Access Compliance Report

Public Rights-of-Way

(Curb Ramps)

Intersection ID: 29756	Main Street: KING_ARTHUR_DR	Cross Street: NIMUE_CT	Location: W
ADA ID: 6A7FD456C75B	Ramp Type: BlendTrans2	Initial Pass/Fail: Fail	Overall Compliance: No
Severity Score: 17.5			
Codes/Mitigation Info/Possible Solution		Field Measurements/Component Compliance

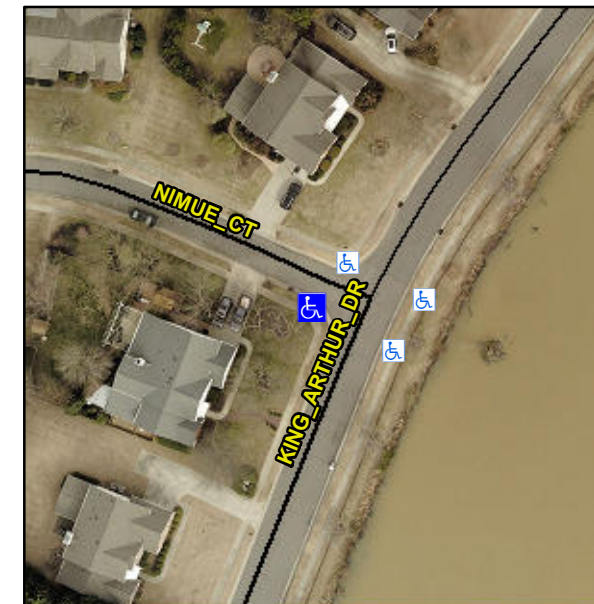
Not Found, R304.5.1

Remove & Replace Curb Ramp With Two New Directional Ramps or Equivalent.
